60% CONSTRUCTION DOCUMENTS BEVERLY PUBLIC SCHOOLS

May 11, 2016

Re: **Beverly Middle School**
Beverly, MA

SKETCH FOR ITEMS # C05 & C06

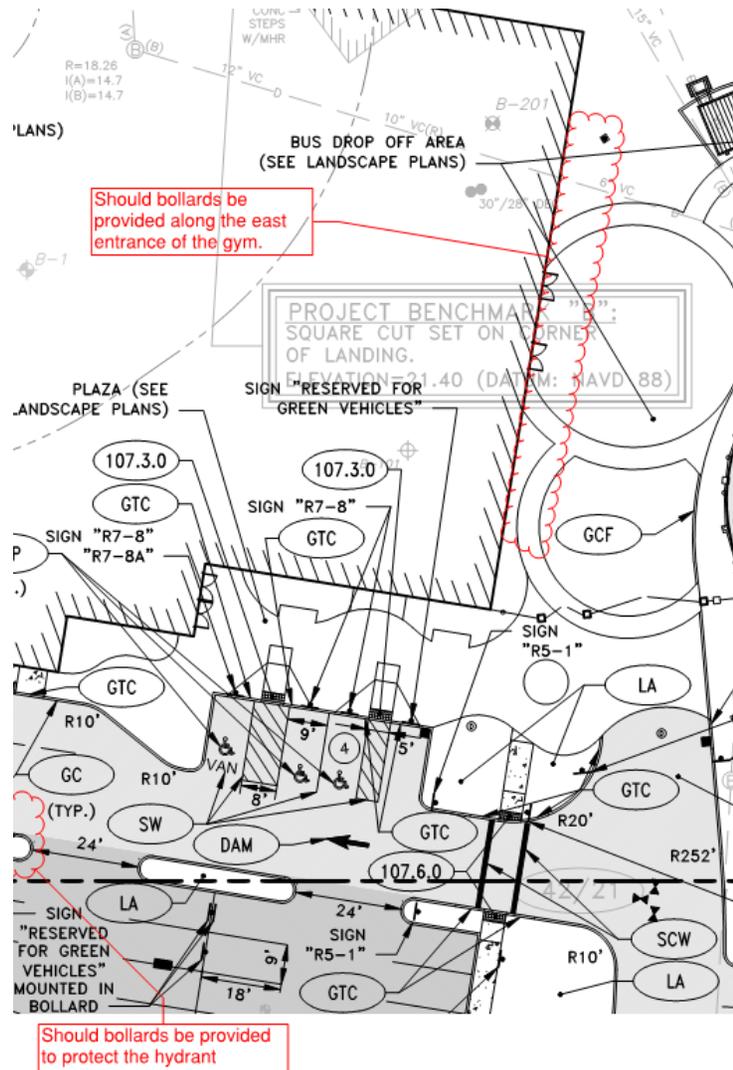
Spec. Sect./ Drawing #	Item	Found BY (Initial)	Comment All comments are suggestions NOT directives	Response Code	Remarks
C2.1	C06	MA	Should bollards be provided to protect the hydrant in the island of the south parking/south of the gym		
C2.1	C07	MA	The plan shows southwest of the bus parking lot a concrete pad with notation "Future Storage Building On Concrete Pad". This notation should be changed to "Concrete Pad for Future Storage Building".		
C2.1 - C2.2	C08	MA	Why is there hay bales/erosion control system showing on the site improvement plan?		
C3.1	C09	DP	Is fencing/guardrail required at loading dock between Elev. 28' & 25.5'		
C3.1	C10	MA	Should the grading for landscaped area west of the auditorium be modified and revised so that the segmental retaining can be eliminated.		
C3.1	C11	MA	The plan shows a segmental retaining wall at the north corner of the site along the north driveway from Cabot Street with same TW and BW wall elevation of 28.0'. The wall should be shortened to match contour elevation of 29.0'. Alternatively, the wall can be eliminated with slight modifications to the grades in that area.
